June 8, 2026

2025-CRW-1019

**Re: Addendum No. One (1)**  
Snow Removal Equipment (SRE) Building  
3-54-0003-087-2025 (Design)  
3-54-0003-XXX-2026 (Construction)  
West Virginia International Yeager Airport (CRW)

2 TYPICAL METAL BUILDING EXTERIOR FOOTING  
1 1/2" = 1'-0"

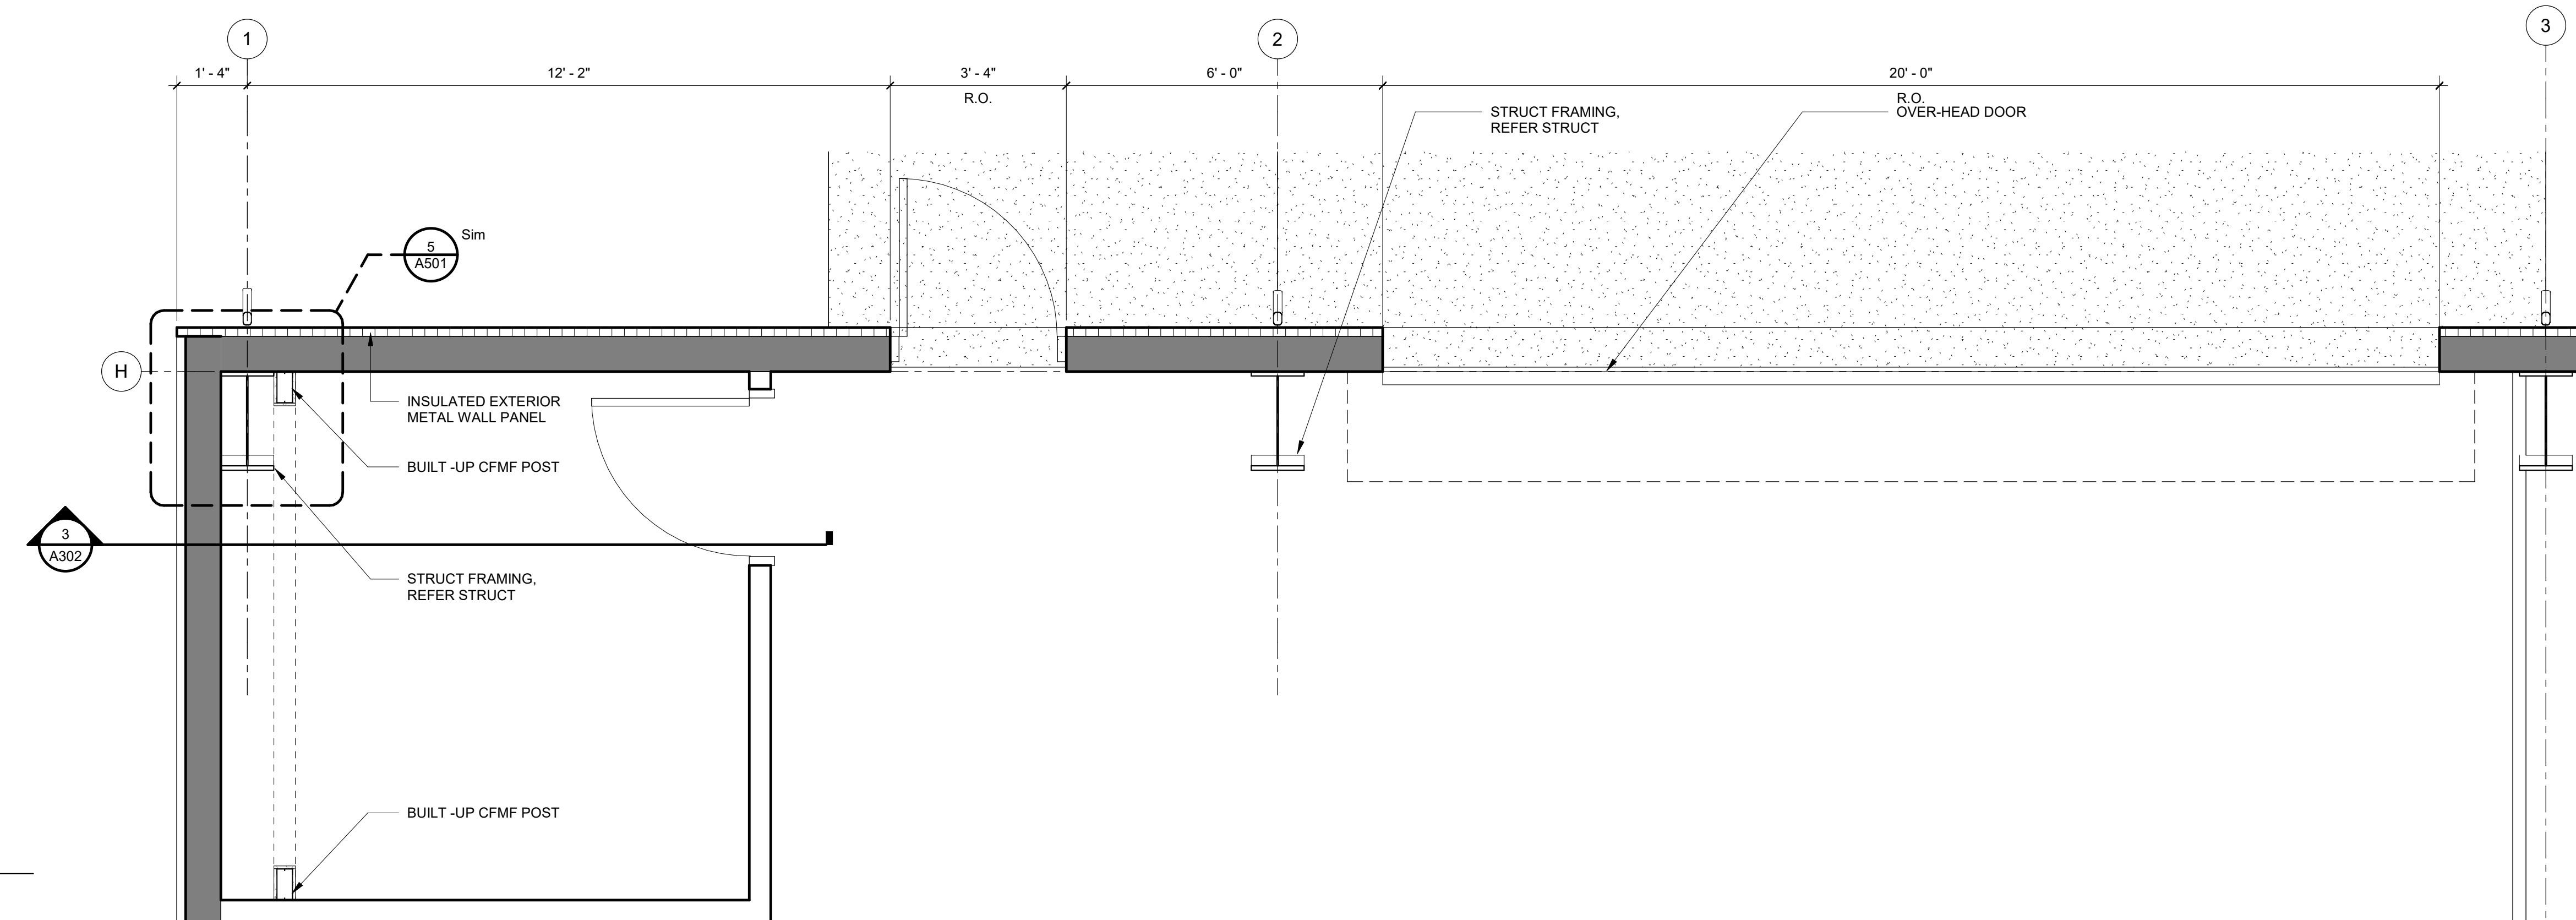
- 1.17.1 **REVISE** Details to show base bid with Metal Panel & Interior Insulation
- 1.18 **REVISE** Drawing No. GC200
- 1.18.1 **REVISE** Major work Items/Suggested Sequence of Construction "Install Drainage Pipes, Floor Drains, Cleanouts and Headwall" to read "Install Drainage Pipes, Inlets and Headwall"

**Q55.** A501 – Detail #6:

**A55. Refer to revised Drawings A303 and A501, added specification section 012300 – Alternates, and revised specification section 133419 Metal Building Systems.**

1 FOUNDATION DETAIL AT EXTERIOR WALL  
3/4" = 1'-0"

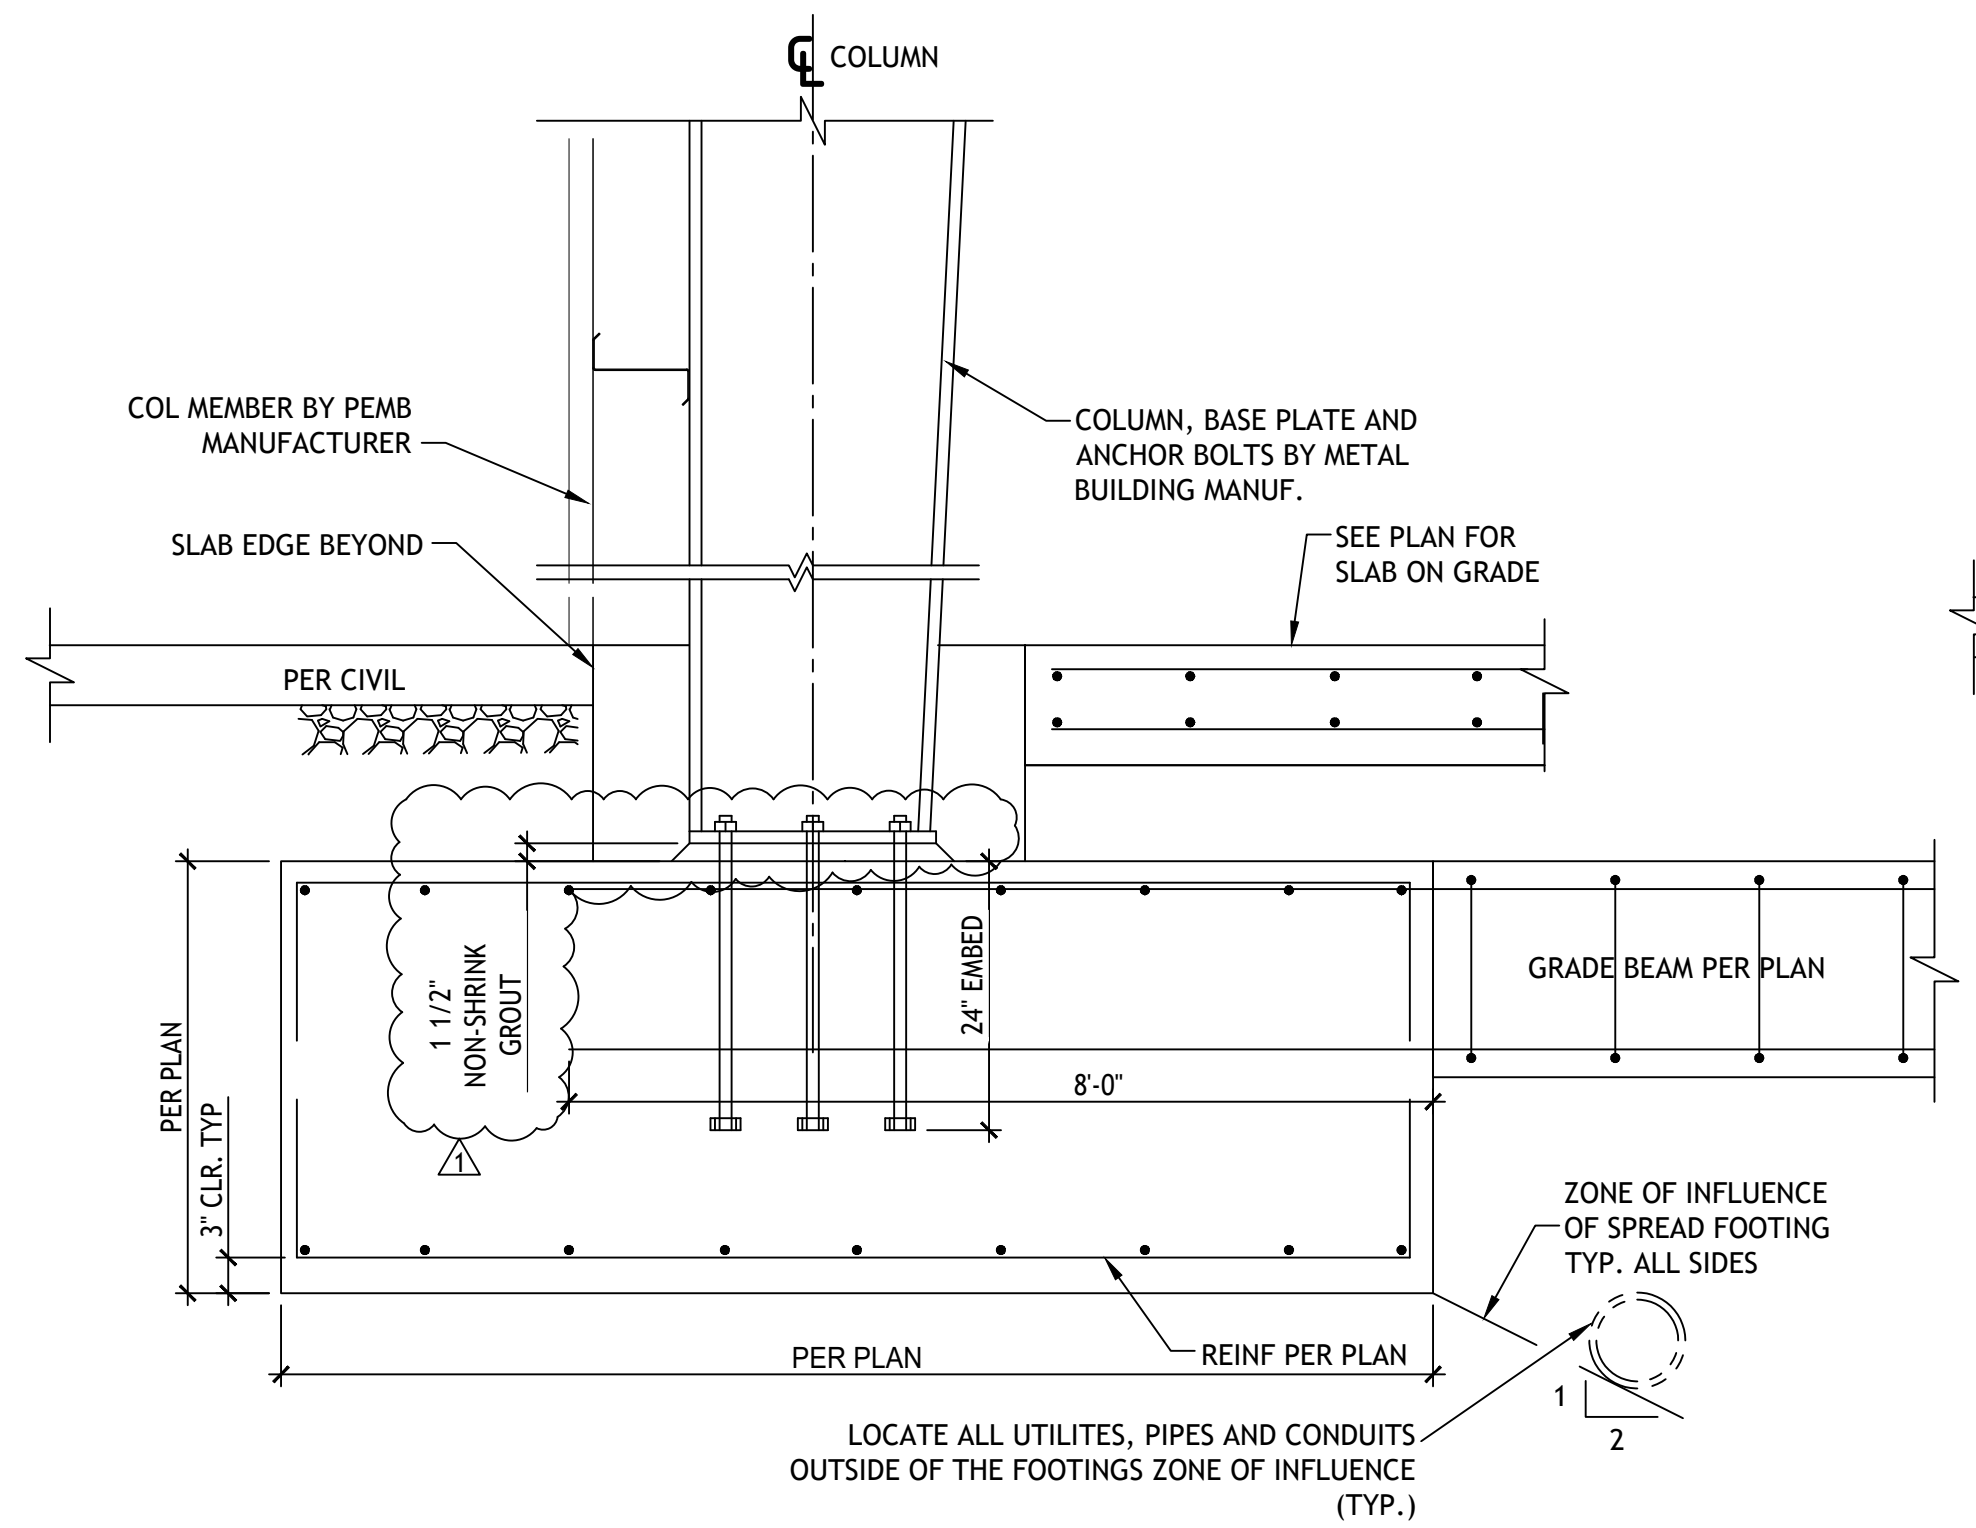
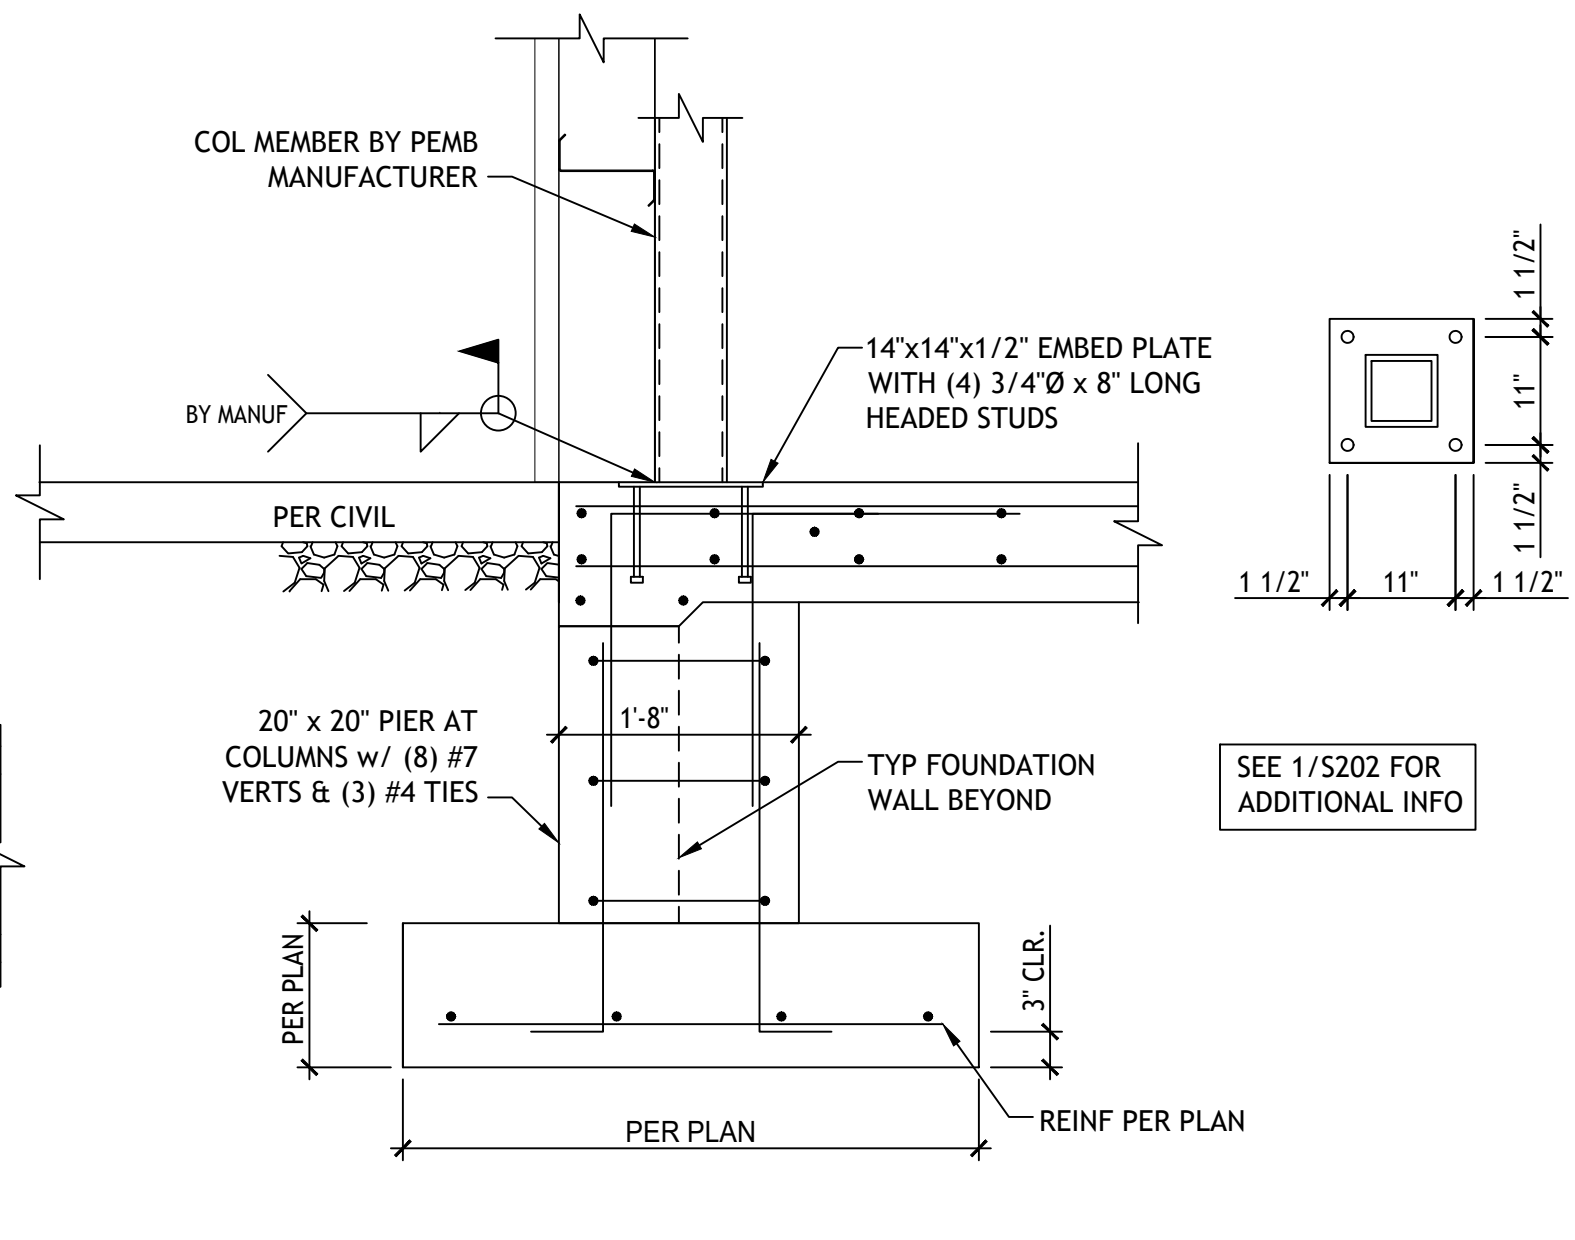
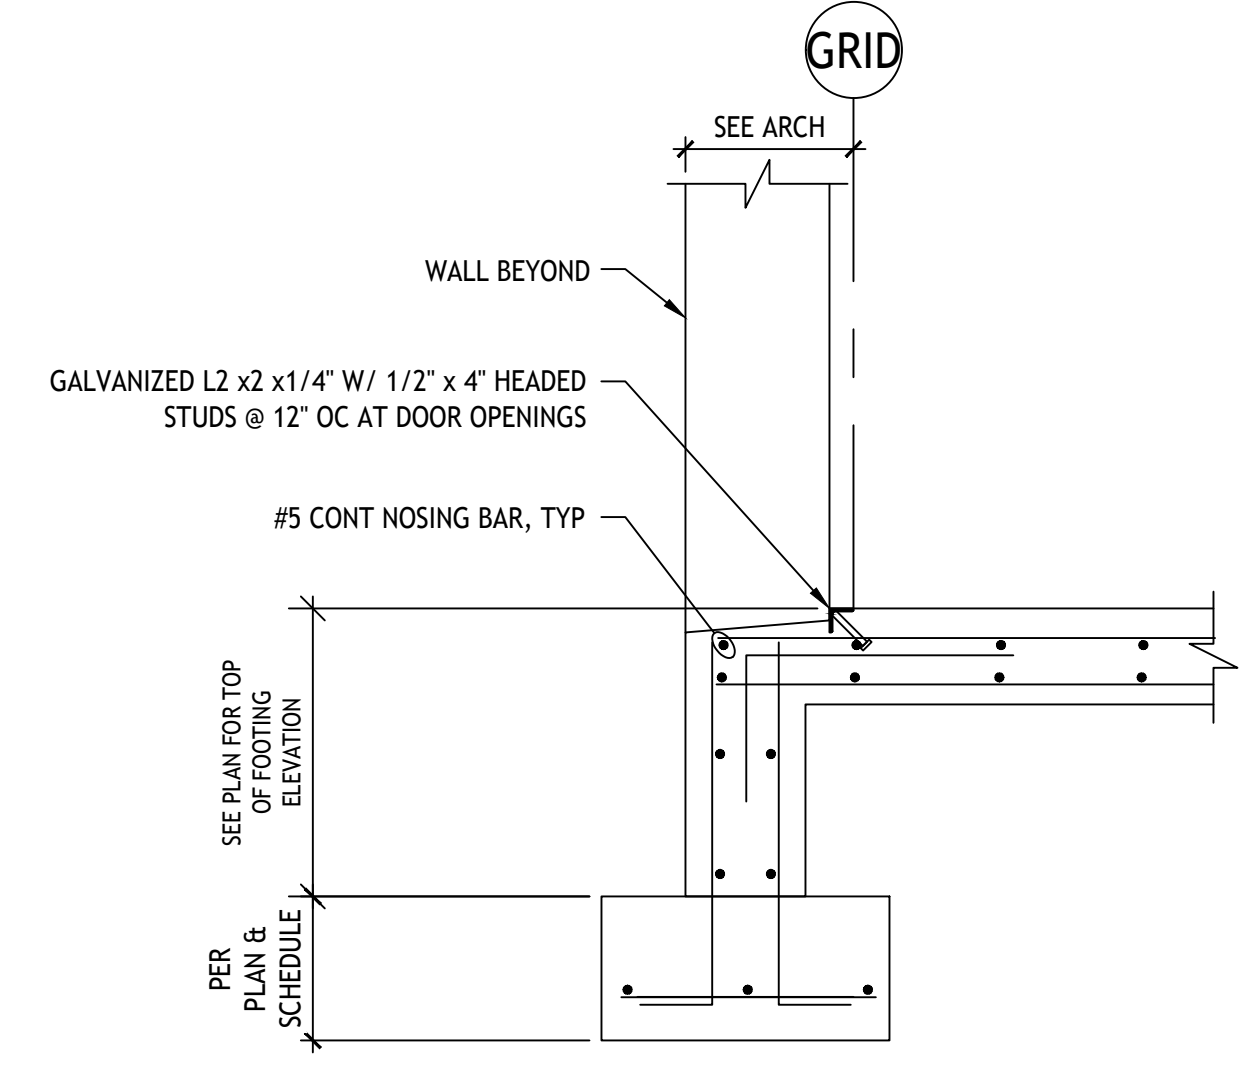
**Q66.** There is no allowance for adjustment of elevation in columns, yet spec section 133419 says to set column base plates with non-shrink grout to achieve full plate bearing. Please clarify, as this adjustment will affect building elevation

**A66. Detail 2/S202 has been revised to specify a grout pad under the column baseplates.**
